SUBJECT: Forwards response to request for addl info on SER Open  
 Items 31, 47, 365 & 139/369.

SHEARON HARRIS NUCLEAR POWER PLANT  
UNIT NOS. 1 AND 2  
DOCKET NOS. 50-400 AND 50-401  
RESPONSES TO REQUESTS FOR ADDITIONAL INFORMATION

Shearon Harris Nuclear Power Plant  
Draft SER Open Item 365  
ASB Question 9.2.2(1)  
Revised Response

Number: <b>F-0.2</b>	Title: <b>CORE COOLING</b>	Rev. Issue/Date: <b>HP/LP, REV. 1</b> <b>1 Sept., 1983</b>
-------------------------	-------------------------------	--

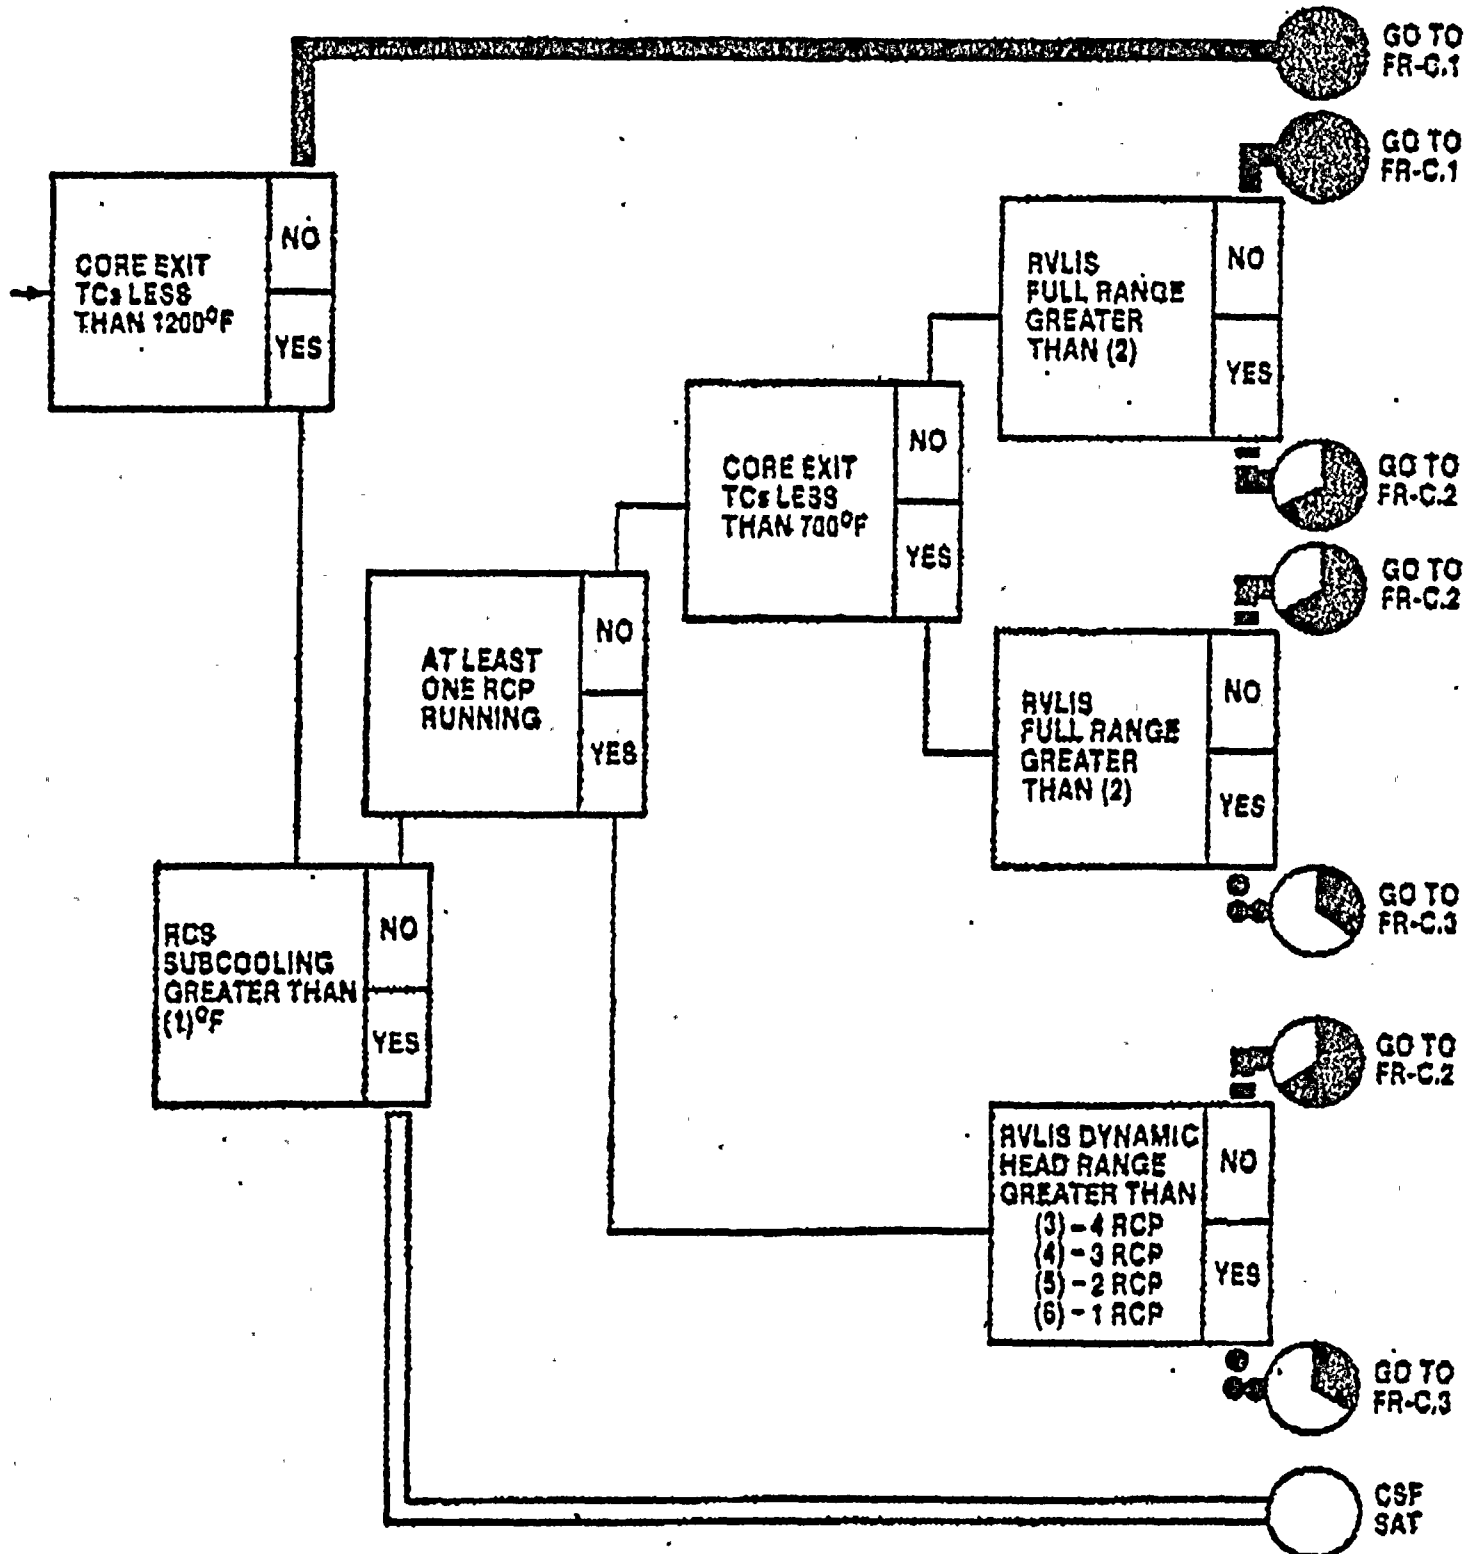
FRG C.2 This guideline will be used when indicated by the core cooling critical safety function status tree (see Attachment 1).

The operator actions specified include:

- (a) Verify safety injection actuation and flowpath alignment.

- (b) Align and actuate systems required to support reactor coolant pump operation.
- (c) Observe trend in inadequate core cooling instrumentation.
- (d) Operate steam system PORVs.
